Access Compliance Report

Public Rights-of-Way

Intersection ID: 48133	Main Street: WHISTLER'S CHASE DR	Cross Street: ACORN CREEK LN	Location: SW
ADA ID: 45EAC6171CDB	Ramp Type: PerpDiag	Initial Pass/Fail: Fail	Overall Compliance: No
Severity Score: 10			
Codes/Mitigation Info/Possible Solution		Field Measurements/Component Compliance

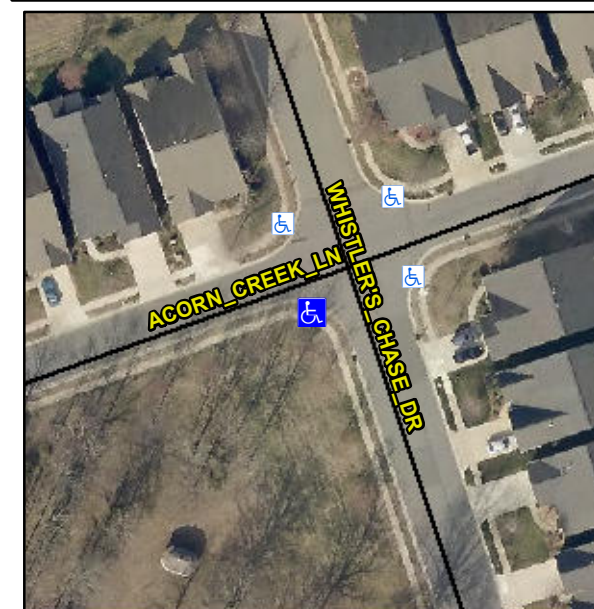
Not Found, R304.5.1, R304.5.3

Compliance	Description	Data	Compliance	Description	Data
N/A	Ramp Length (in)	47.5	Yes	Ramp Slope (%)	6.6
No	Ramp Width (in)	43.0	No	Ramp XSlope (%)	2.2
N/A	Flare Type LT	N/A	N/A	Flare Type RT	N/A
N/A	Flare Slope LT (%)	N/A	N/A	Flare Slope RT (%)	N/A
N/A	Flare Traversable LT?	N/A	N/A	Flare Traversable RT?	N/A
N/A	Landing Length (in)	N/A	N/A	DWS Provided?	N/A
N/A	Landing Width (in)	N/A	N/A	DWS Contrast?	N/A
N/A	Landing Slope (%)	N/A	N/A	DWS Length (in)	N/A
N/A	Landing X Slope (%)	N/A	N/A	DWS Full Width?	N/A
N/A	Landing Curb? (Y/N)	N/A	N/A	DWS Offset (in)	N/A
N/A	Shared Landing?	N/A			
N/A	Gutter Ponding?	N/A	N/A	Gutter Slope (%)	N/A
N/A	Gutter Lip Ht (in)	N/A	N/A	Gutter X Slope (%)	N/A
N/A	Painted X Walk1?	No	N/A	Painted X Walk2?	No
	X Walk 1 Direction	To E		X Walk 2 Direction	To N
N/A	X Walk 1 Width (in)	N/A	N/A	X Walk 2 Width (in)	N/A
	X Walk 1 Slope (%)	2.5		X Walk 2 Slope (%)	5.0
	X Walk 1 X Slope (%)	4.7		X Walk 2 X Slope (%)	0.2

Remove & Replace Curb Ramp With Two New Directional Ramps or Equivalent.
